Serial: RNP-RA/17-0082
February 7, 2018

H.B. ROBINSON STEAM ELECTRIC PLANT, UNIT NO. 2
DOCKET NO. 50-261
RENEWED LICENSE NO. DPR-23

**SUBJECT: LICENSE AMENDMENT REQUEST PROPOSING TO REVISE TECHNICAL
SPECIFICATION 3.4.3, "RCS PRESSURE AND TEMPERATURE (P/T) LIMITS"**

Figure 3.4.3-1
Reactor Coolant System Heatup Limits
Applicable Up to 50 EFY

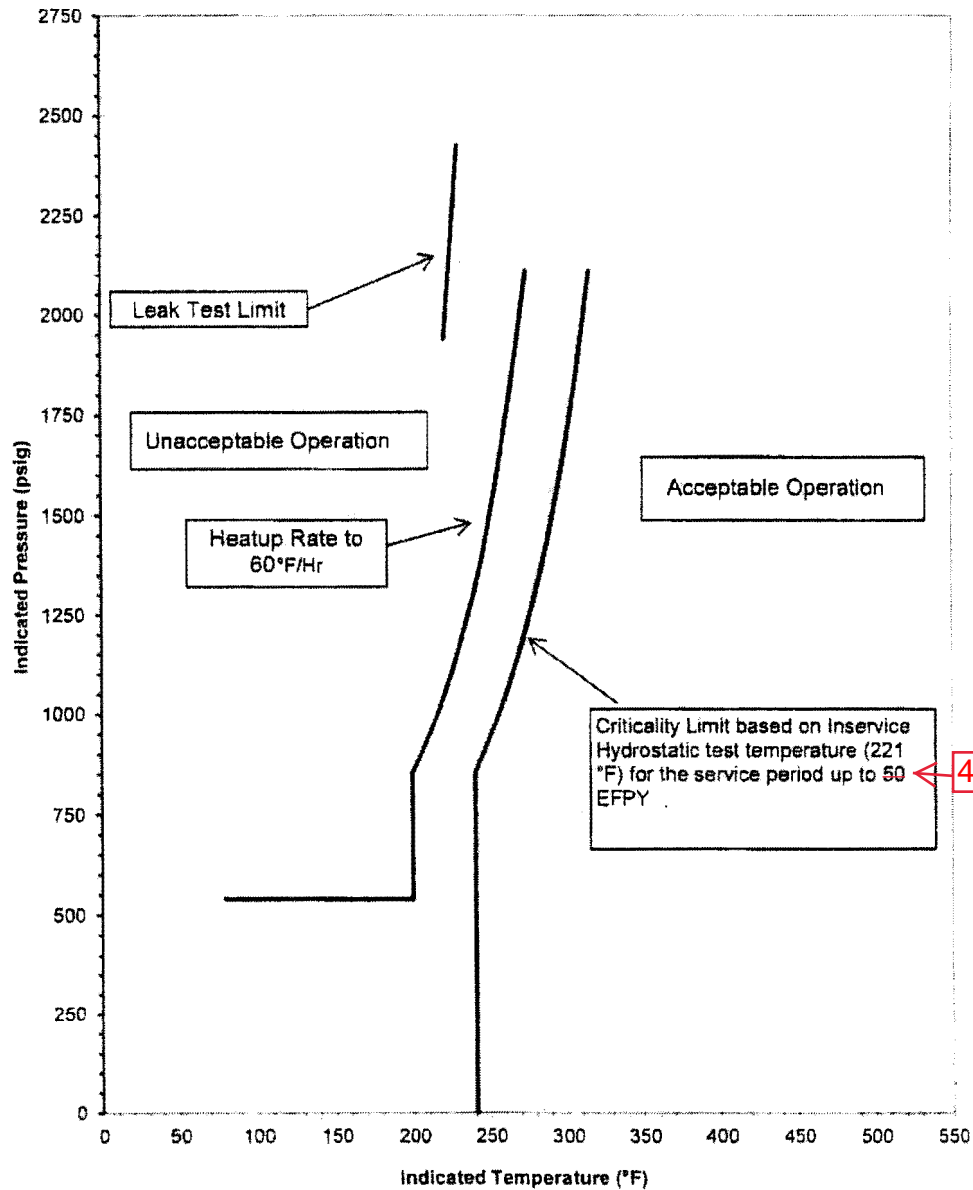
TS 3.4.3, Figure 3.4.3-1, “Reactor Coolant System Heatup Limits Applicable Up to 50 EFPY,” is revised as follows:

- The words “Limiting ART Values at 50 EFPY” are revised to state “Limiting ART Values at 46.3 EFPY”.
- The words “Curves applicable for heatup rates up to 60°F/Hr for service period up to 50 EFPY” are revised to state “Curves applicable for heatup rates up to 60°F/Hr for service period up to 46.3 EFPY”.
- The words “Criticality Limit based on Inservice Hydrostatic test temperature (221°F) for the service period up to 50 EFPY” are revised to state “Criticality Limit based on Inservice Hydrostatic test temperature (221°F) for the service period up to 46.3 EFPY”.
- The title of Figure 3.4.3-1 (“Reactor Coolant System Heatup Limits Applicable Up to 50 EFPY”) is revised to state “Reactor Coolant System Heatup Limits Applicable Up to 46.3 EFPY”.

Figure 3.4.3-2
Reactor Coolant System Cooldown Limitations
Applicable Up to 50 EFY

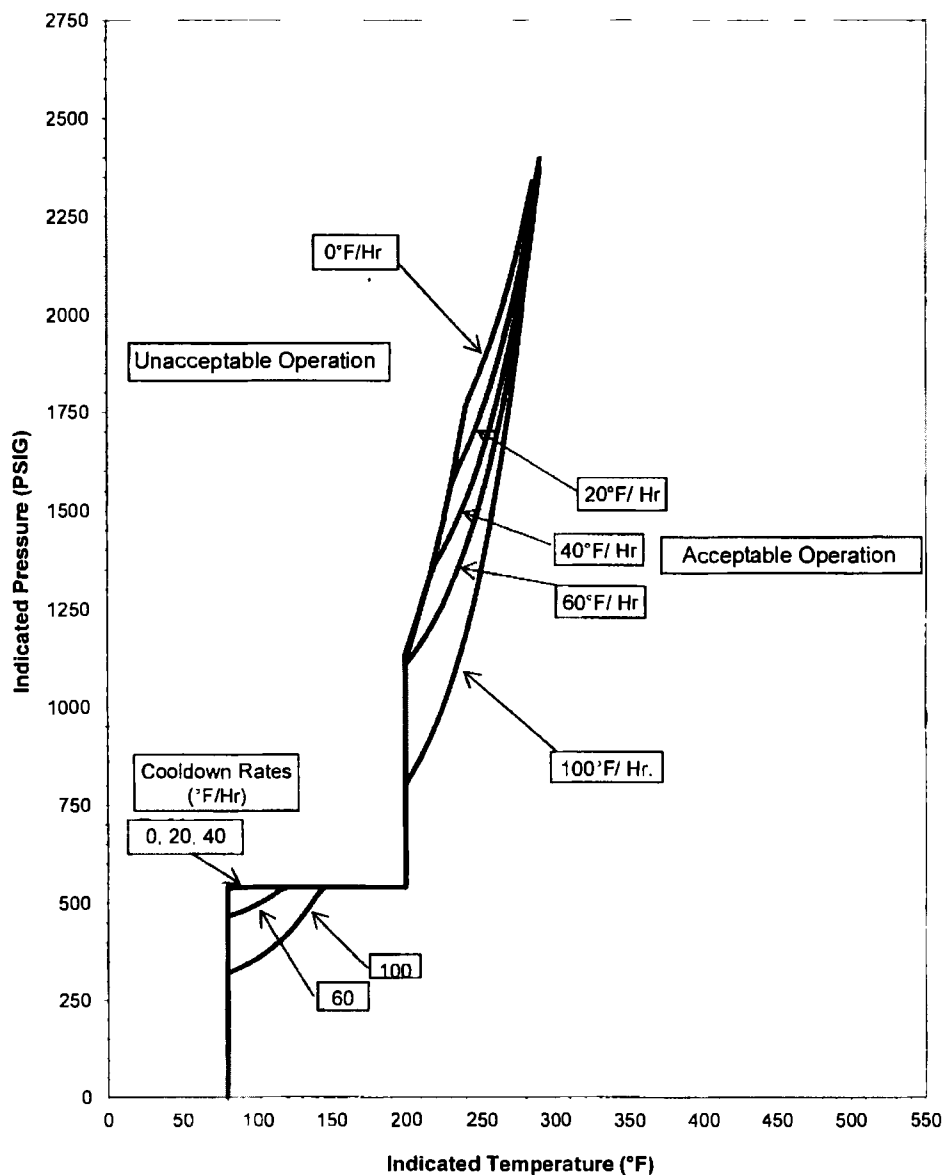
TS 3.4.3, Figure 3.4.3-2, “Reactor Coolant System Cooldown Limitations Applicable Up to 50 EFPY,” is revised as follows:

- The words “Limiting ART Values at 50 EFPY” are revised to state “Limiting ART Values at 46.3 EFPY”.
- The words “Curves applicable for cooldown rates up to 100°F/Hr for the service period up to 50 EFPY.” are revised to state “Curves applicable for cooldown rates up to 100°F/Hr for the service period up to 46.3 EFPY.”

- The title of Figure 3.4.3-2 (“Reactor Coolant System Cooldown Limitations Applicable Up to 50 EFPY”) is revised to state “Reactor Coolant System Cooldown Limitations Applicable Up to 46.3 EFPY”.
